FARRAGUT VISUAL RESOURCES REVIEW BOARD AGENDA

Farragut Community Center
Large Classroom
Tuesday, January 23, 2024
7:00 p.m.

MEMORANDUM

TO: Farragut Visual Resources Review Board
FROM: Bart Hose, Assist. Community Development Director
SUBJECT: Regularly Scheduled Meeting - Tuesday, January 23, 2024, at 7:00 p.m.

Dunkin' - 13038 Kingston Pike (Kingston Pike Elevation)

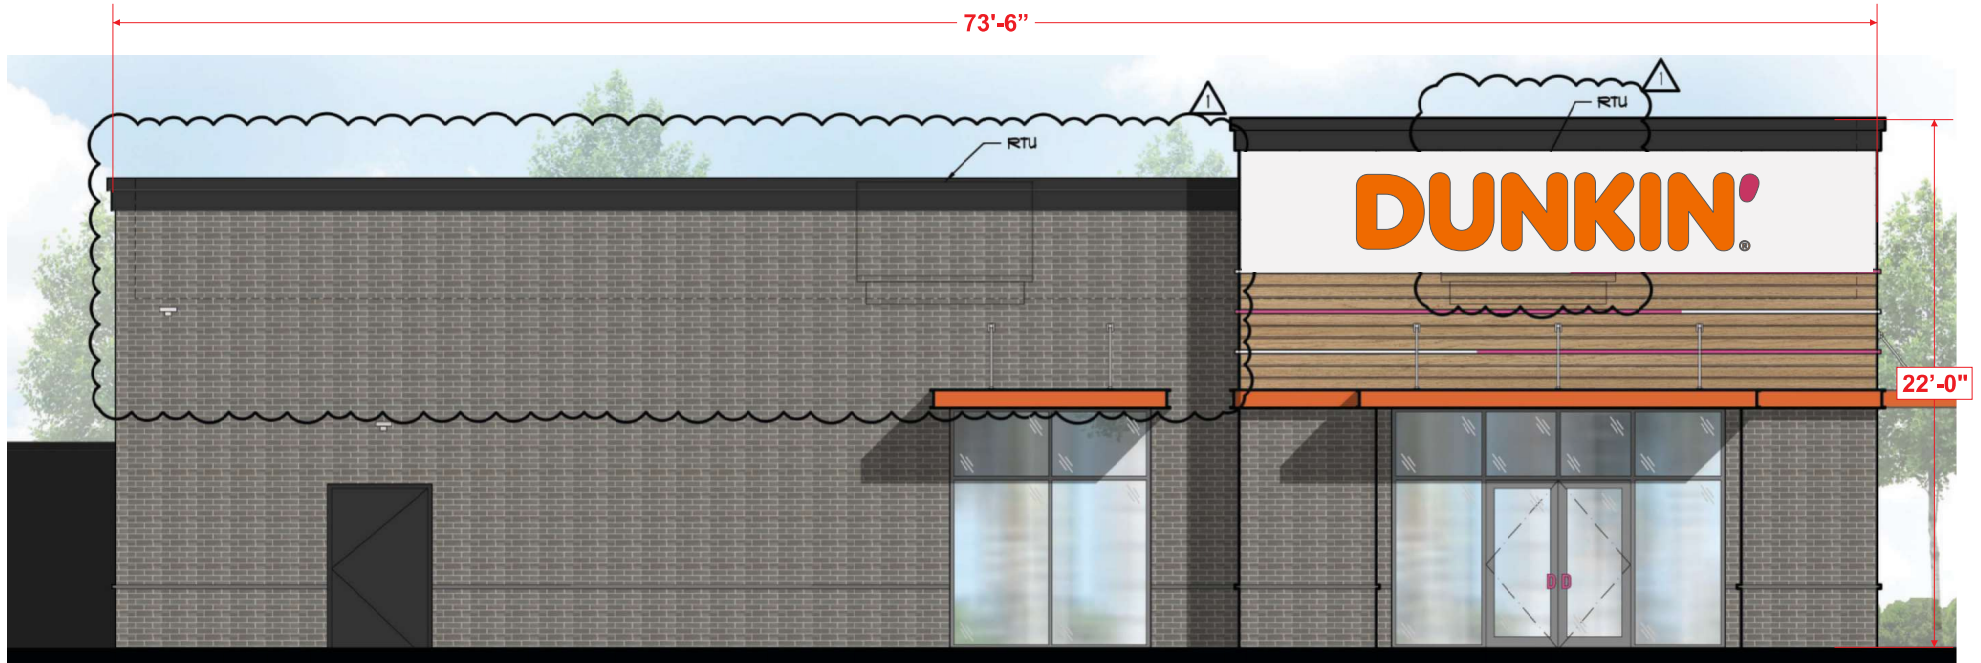
Sign approved as submitted. The approved sign is 28.19 square feet on 30' Linear building wall. Orange channel letters and pink apostrophe with gray returns individually mounted to wall fascia. Internally illuminated with white LED's. This location has 2 signs. The Kingston Pike elevation sign is the 1:1 ratio sign.

a) Balanced Paws – Located at 11135 Kingston Pike

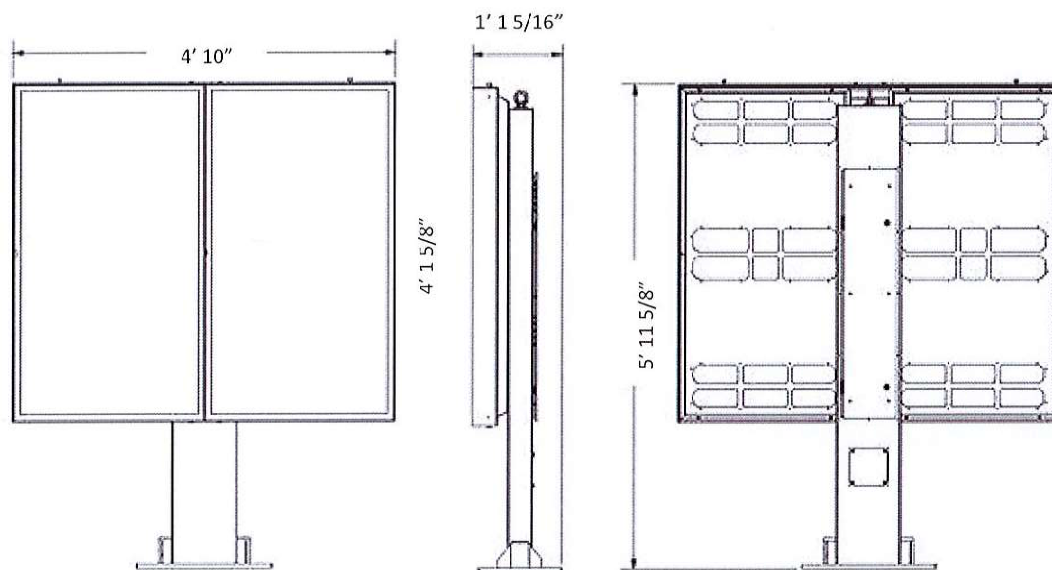
Balanced Paws is requesting approval for an individual tenant panel sign located at 11135 Kingston Pike.

The panel is designed with a white background to be consistent with the other panels on the larger sign. Although staff thinks that the sign would be more effective if it focused on the name of the business, the “Dog Training” element of the message appears to be as legible as other panels on the sign.

Coates ODMB Measurements

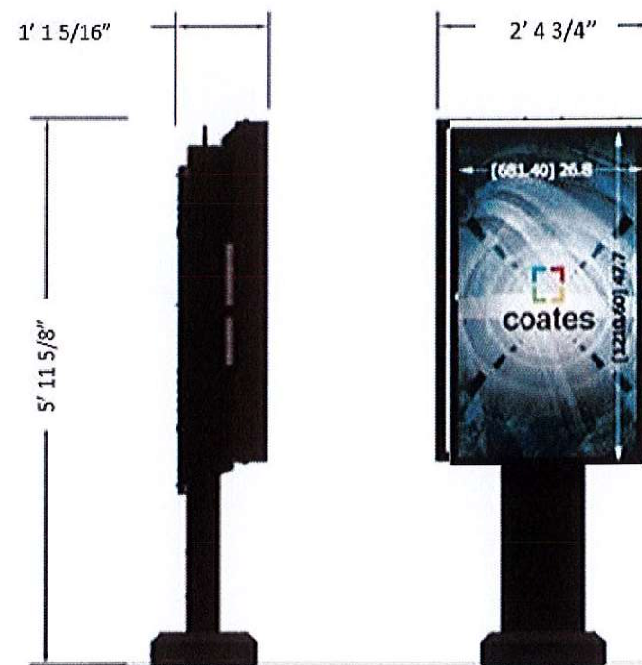
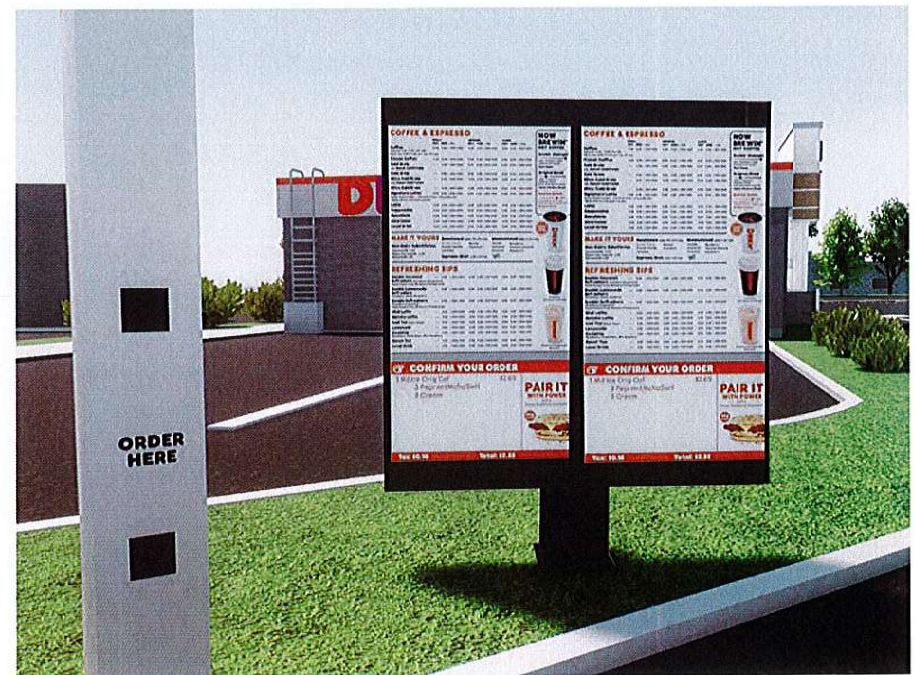
Dunkin Donuts is requesting approval for a replacement menu board ground sign located at 712 N. Campbell Station Rd.

The applicant is requesting approval to install a replacement menu board sign and associated apparatus/equipment. The materials submitted to date are either non-compliant or incomplete and do not adequately demonstrate compliance. The regulations do not provide for both a menu board and a pre-sell board, and the single allowable order box sign cannot be more than 1 square foot in area and cannot exceed 30 inches in height. A site location plan sheet is also required. Finally, the order station canopy support structure will need to be done in a color that is compatible with the building façade to comply with the Architectural Design Standards. The applicant is aware of these issues but has not yet submitted fully revised and compliant plan materials.

TURKEY CREEK WOODS

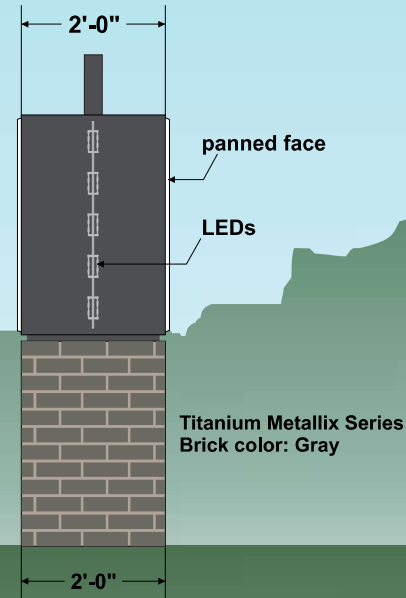
Turkey Creek Woods Subdivision is requesting approval to reface two existing subdivision entrance signs.

The application involves two new/replacement sign face panels for the existing monument signs at the entrances to Turkey Creek Woods Subdivision. The existing monument signs were approved in 1995 with 2 x 8-foot inset panels to accommodate the actual sign face. These inset panels are somewhat larger than would be allowable today, but they are tied to the inset space built into the larger brick monument structure. The staff can recommend approval subject to the following:

1. Confirming the material to be used for the sign inset.
2. Providing additional details for the proposed landscaping. The staff would suggest the use of some low growing, low maintenance shrubs.
3. Providing additional details for the proposed external lights.

FILE:
Dunkin Monument Farragut

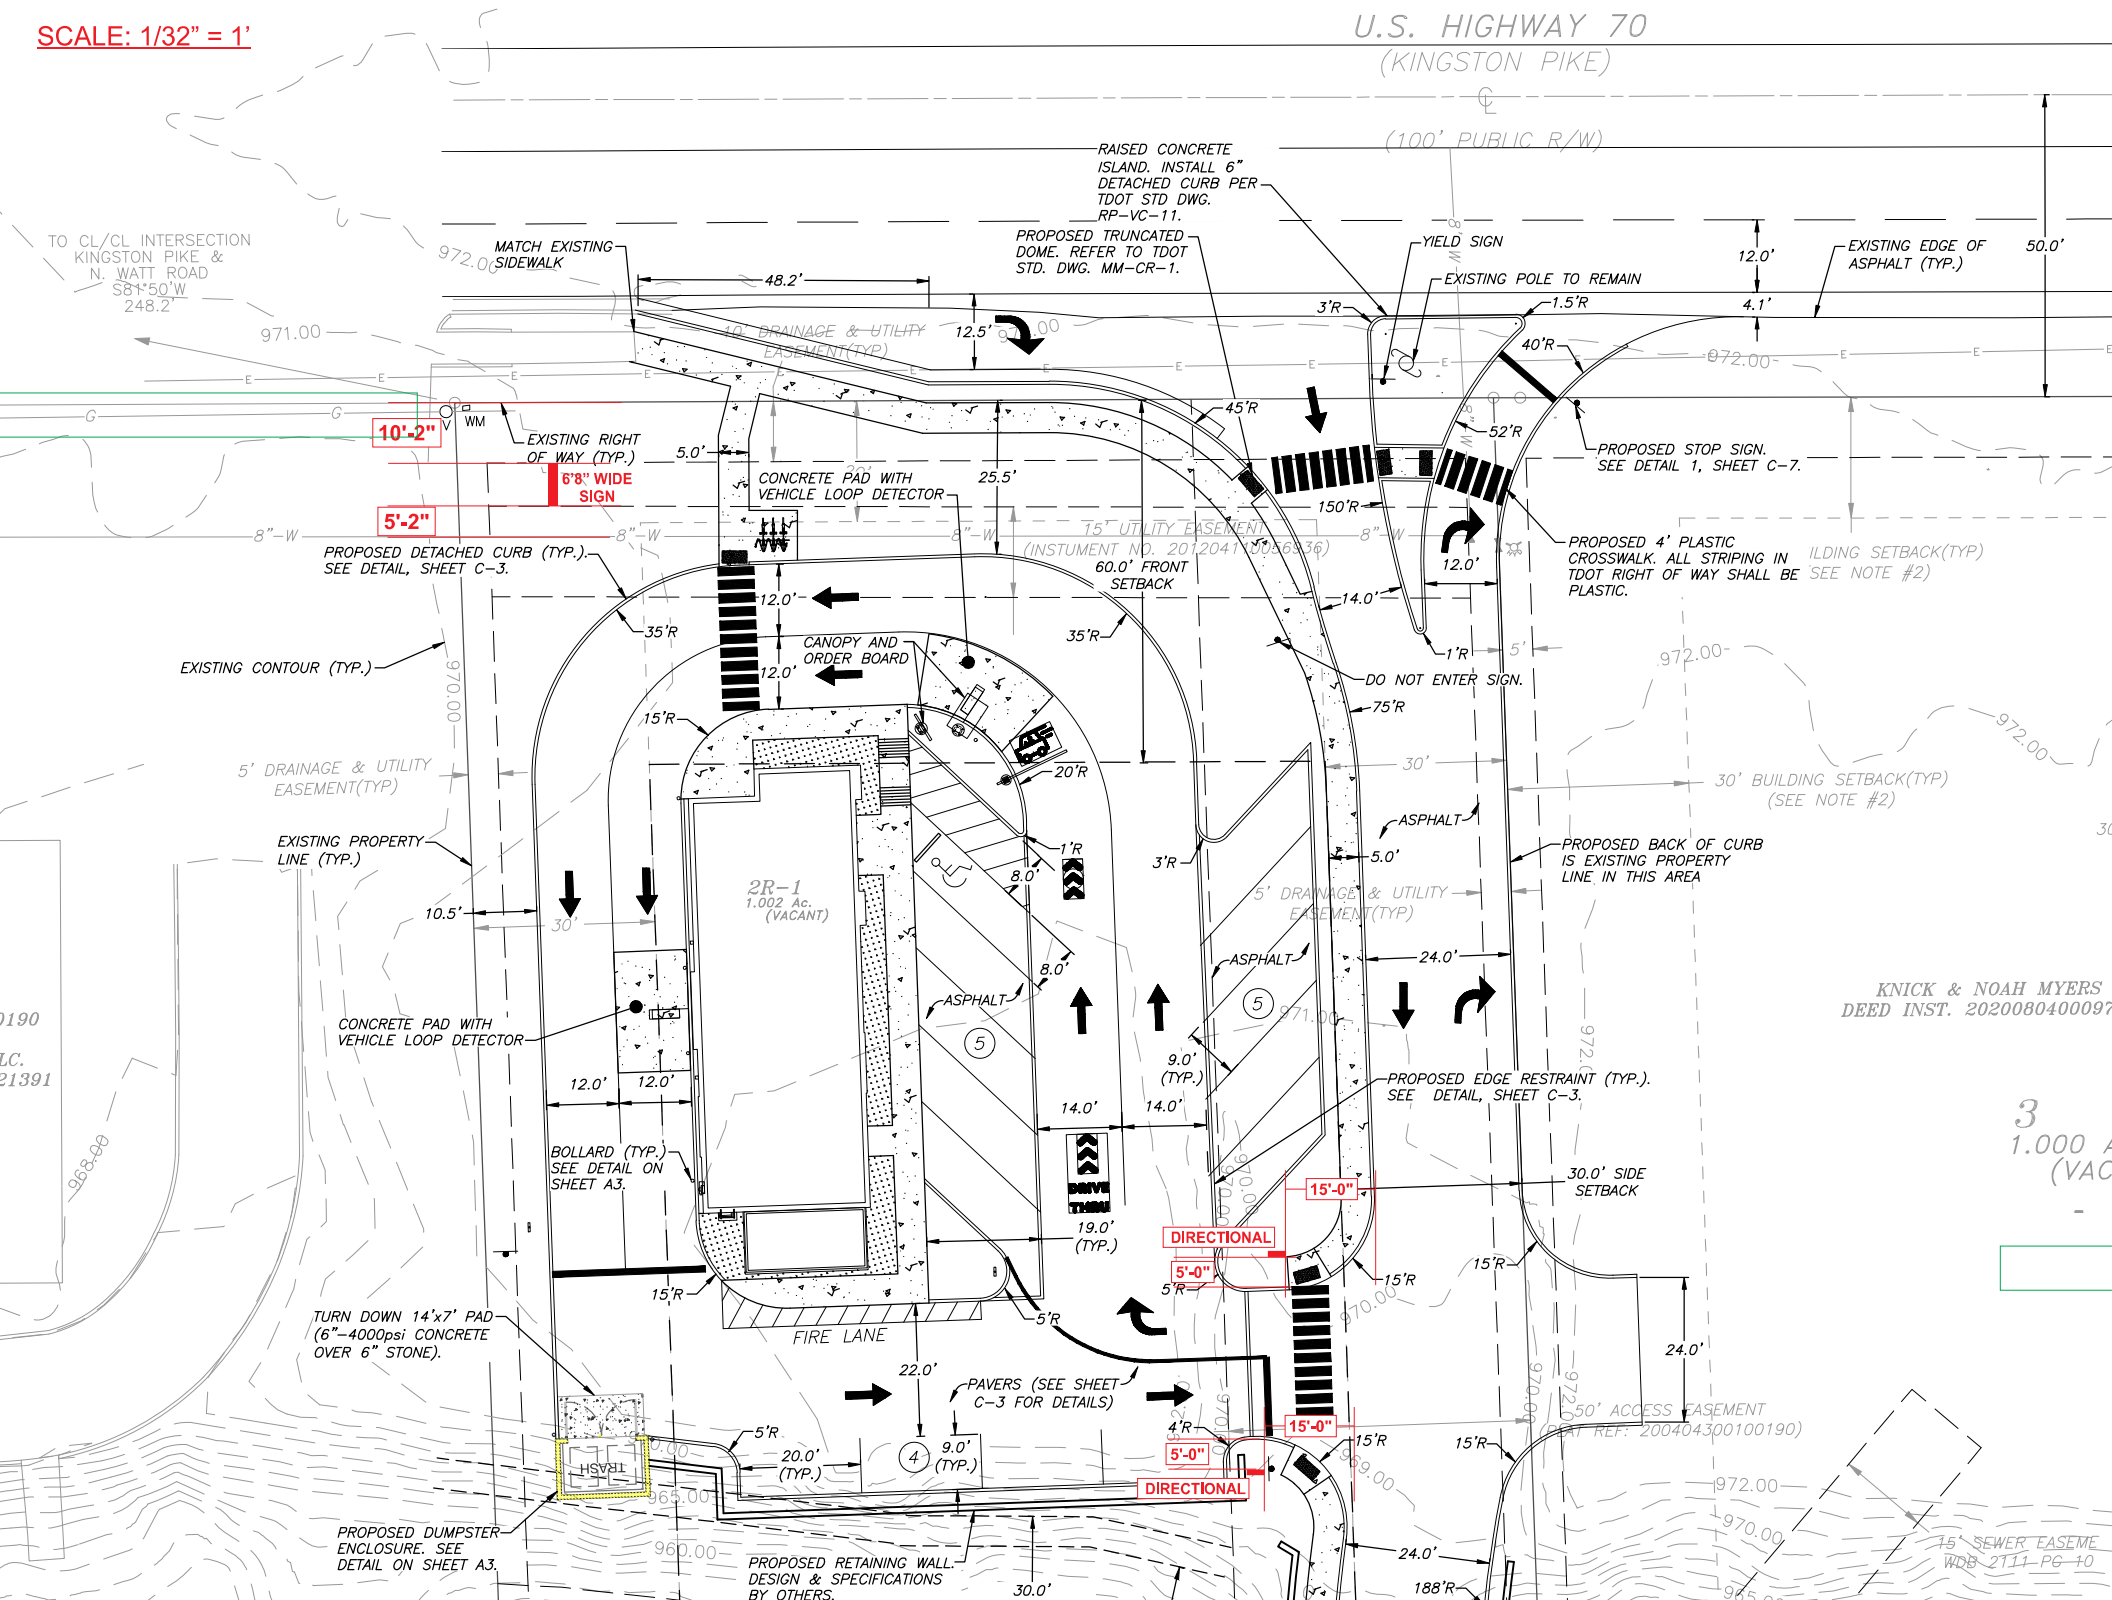
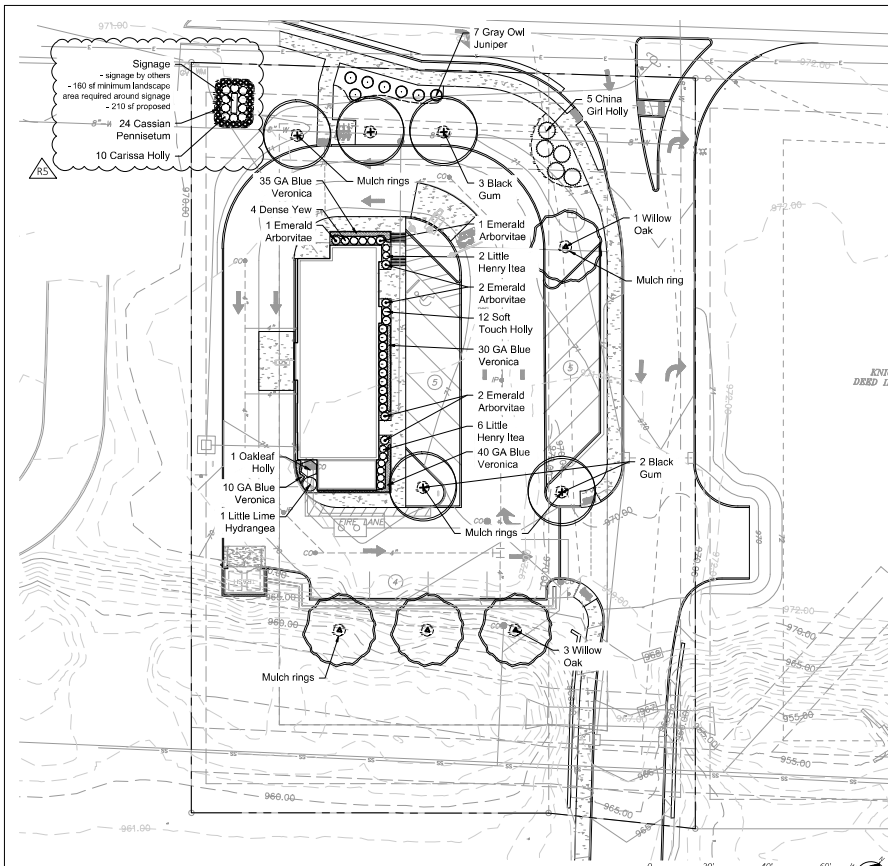
Dunkin is requesting approval for a primary ground mounted sign located at 13038 Kingston Pike.

The applicant is requesting approval to install a monument type ground sign for the new Dunkin Donuts being developed at 13038 Kingston Pike. The proposed sign and plans are compliant, and the staff can recommend approval.

FILE: Dunkin Directionals Farragut

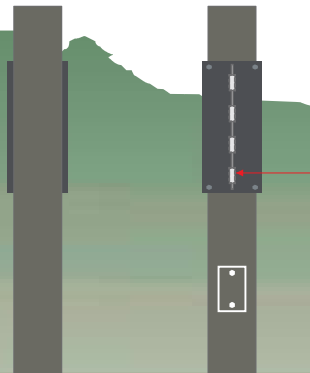
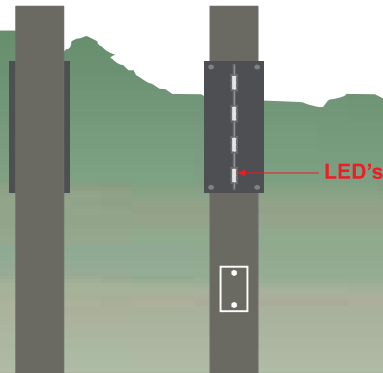
Dunkin is requesting approval for two peripheral accessory freestanding signs located at 13038 Kingston Pike.

The applicant is requesting approval to install two accessory entrance type signs for the new Dunkin Donuts being developed at 13038 Kingston Pike. The proposed signs and plans are compliant, and the staff can recommend approval.
